ADDENDUM NO. 1

Rehabilitation of Lift Stations No. 3 and No. 39

City of Mandeville, Louisiana

City Project No. 212.22.002

RISER DIAGRAM - LS 3
CITY OF MANDEVILLE, LOUISIANA
SHEET 1-E2
FCE 21-061A

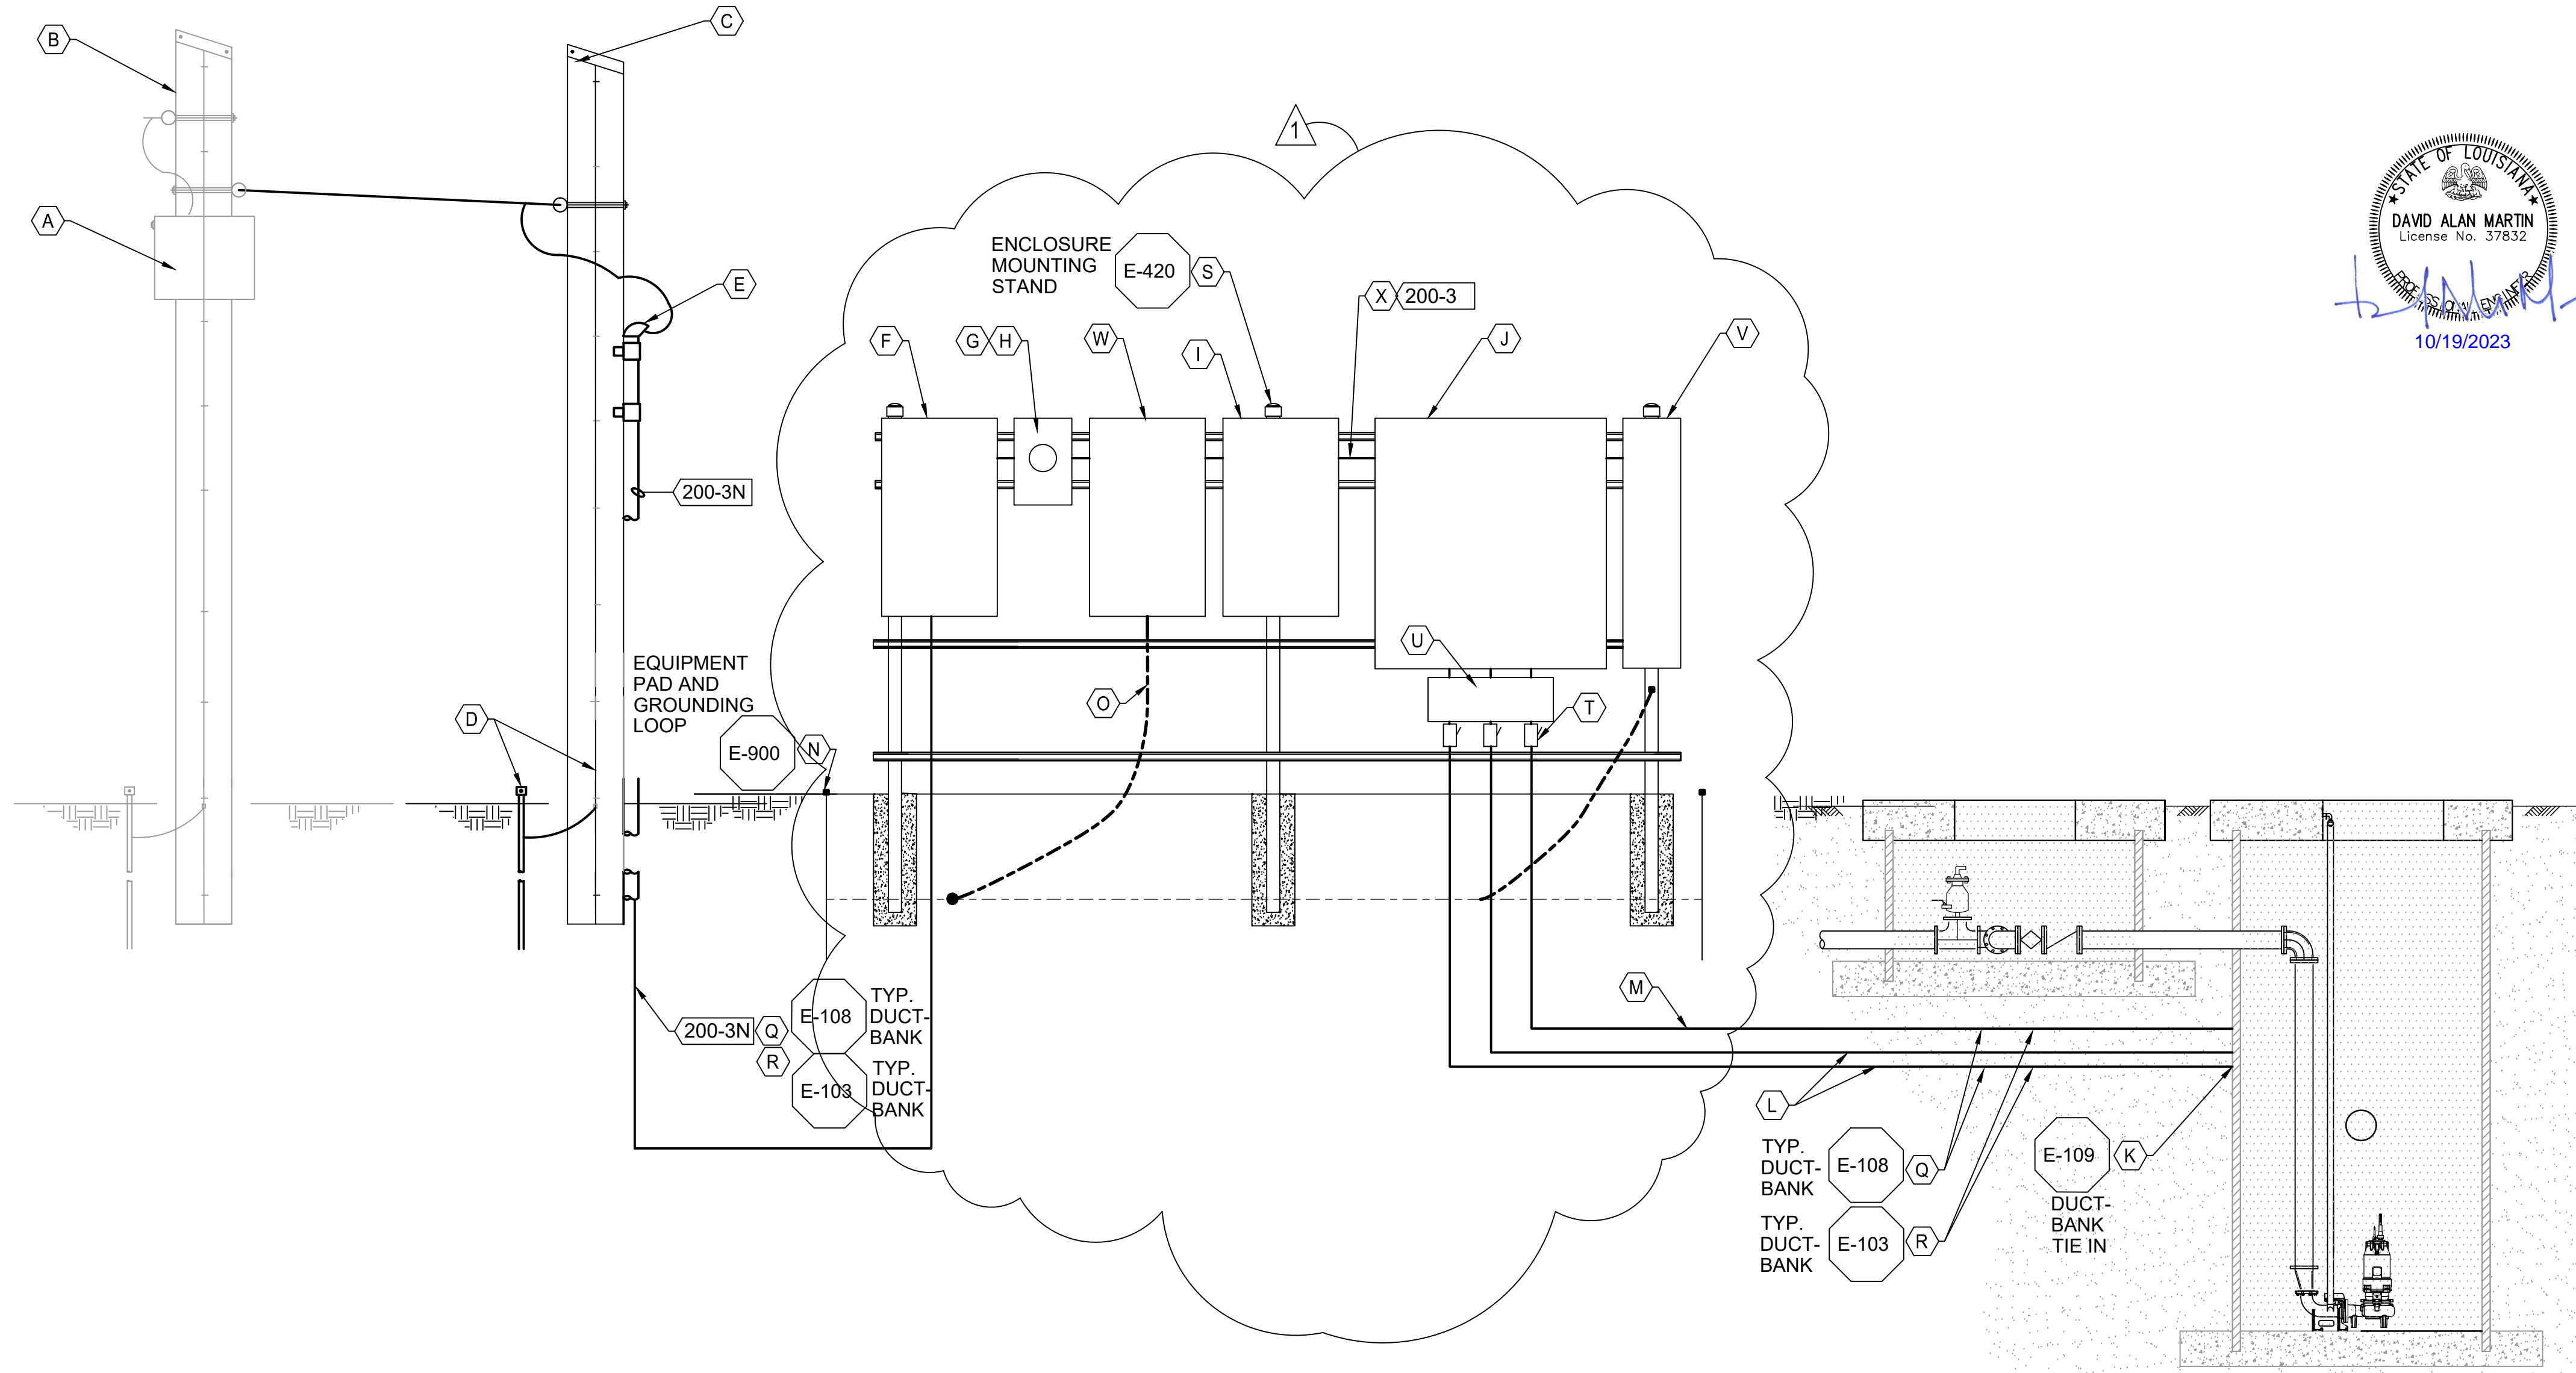
- C2.** Question: Who is the existing contractor for the lift station controls? Answer: Station 3 currently operates on a panel produced by Custom Controls Technology (CCT). Station 39 currently operates on a panel produced by TESCO Controls.
- C3. Question:** Are the duct banks on LS 3 necessary from box to box? Would be simpler and cheaper to nipple into each panel from the side. **Answer:** Nipples may be used to make necessary runs between rack mounted equipment. See changes to Contract Drawings.

- D1. DELETE** Sheet 1-E2 and REPLACE with the attached REVISED Sheet 1-E2.

- X. CONTRACTOR MAY USE NIPPLES FOR RUNS BETWEEN RACK MOUNTED EQUIPMENT.
